## **Access Compliance Report Public Rights-of-Way** (Curb Ramps)

Intersection ID: N/A Main Street: TAMARACK DR **Cross Street: SINGLELEAF LN** Location: W **Overall Compliance: No** ADA ID: 8FBF3671AE42 Ramp Type: BlendTrans1 Initial Pass/Fail: Fail **Severity Score:** 1.25

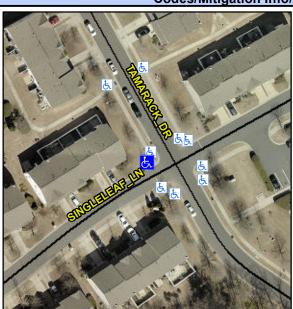
Not Found, R304.5.3

Field Measurements/Component Compliance						
Compliance Description		Data	Comp	liance Description	Data	
N/A	Ramp Length (in)	49.0	Yes	BlendTrans Slope (%)	3.6	
Yes	Ramp Width (in)	48.0	No	BlendTrans XSlope (%)	4.2	
N/A	Flare Type LT	N/A	N/A	Flare Type RT	N/A	
N/A	Flare Slope LT (%)	N/A	N/A	Flare Slope RT (%)	N/A	
N/A	Flare Traversable LT?	No	N/A	Flare Traversable RT?	No	
N/A	Landing Length (in)	N/A	N/A	DWS Provided?	N/A	
N/A	Landing Width (in)	N/A	N/A	DWS Contrast?	N/A	
N/A	Landing Slope (%)	N/A	N/A	DWS Length (in)	N/A	
N/A	Landing X Slope (%)	N/A	N/A	DWS Full Width?	N/A	
N/A	Landing Curb? (Y/N)	N/A	N/A	DWS Offset (in)	N/A	
N/A	Shared Landing?	N/A				
N/A	Gutter Ponding?	N/A	N/A	Gutter Slope (%)	N/A	
N/A	Gutter Lip Ht (in)	N/A	N/A	Gutter X Slope (%)	N/A	
N/A	Painted X Walk1?	No	N/A	Painted X Walk2?	N/A	
	X Walk 1 Direction	To SE		X Walk 2 Direction	N/A	
	X Walk 1 Width (in)	N/A		X Walk 2 Width (in)	N/A	
	X Walk 1 Slope (%)	0.0		X Walk 2 Slope (%)	N/A

X Walk 1 X Slope (%)	1.4		X Walk 2 X Slope (%)	N/A	
N/A	Ramp inside XWalk1?	N/A	N/A	Ramp inside XWalk2?	N/A	
	Road Slope (%)	1.4		Clear Space?	N/A	
	Road X Slope (%)	0.0	N/A	Clear Space to XWalk (in)	N/A	
N/A	Any Obstructions?	N/A	N/A	Storm Grate/Utility Hazard?	N/A	
	Obstruction Type			Storm Grate/Utility Type		
		N/A			N/A	
			Yes	Surface Condition? (G/P)	Good	
			No	Curb Slope (%)	7.0

Remove & Replace Curb Ramp With Two New Directional Ramps or Equivalent.
